February 11, 2022

**RE: Dions – Ventana Square
Grading & Drainage Plan
Engineer's Stamp Date: 11/30/21
Hydrology File: B10D003H**

Grading Plan

C-100

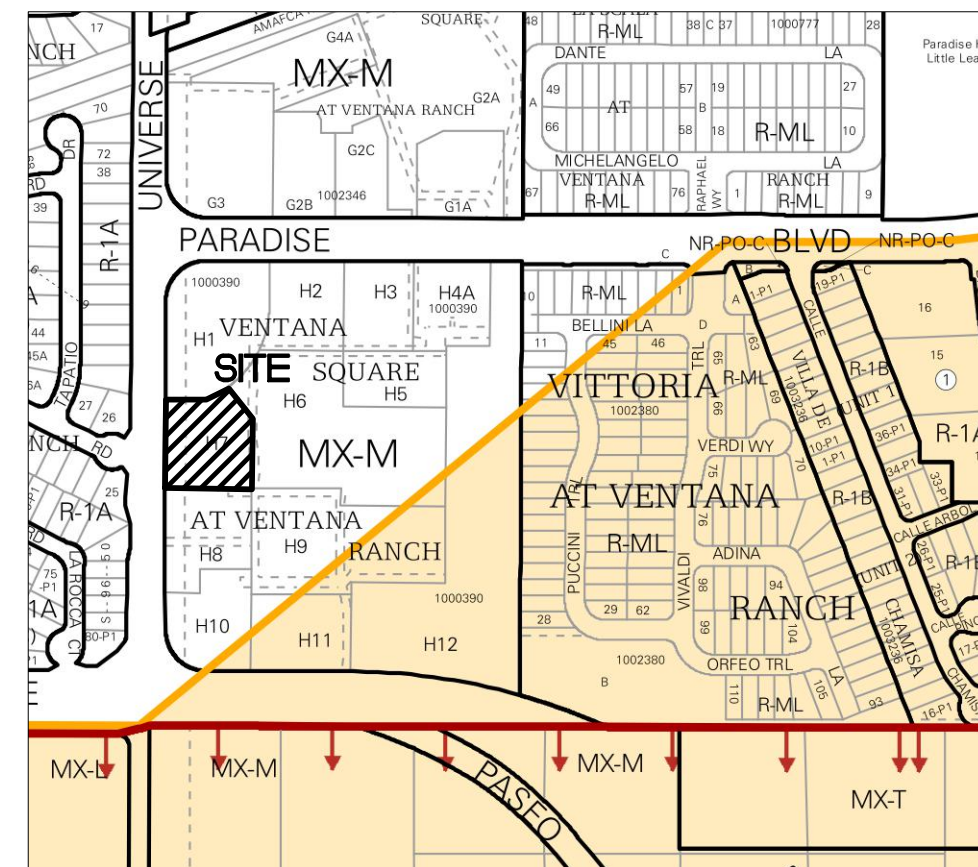
1. Engineer's Certification, per the DPM Part 6-14 (F): *Engineer's Certification Checklist For Non-Subdivision* is required.

2. Please provide the Drainage Covenant with Exhibit A for the stormwater quality ponds per Article 6-15(C) of the DPM prior to Permanent Release of Occupancy. Please submit the original copies along with the \$ 25.00 recording fee check made payable to Bernalillo County to Marion G. Velasquez (mgvelasquez@cabq.gov) on the 4th floor of Plaza de Sol.
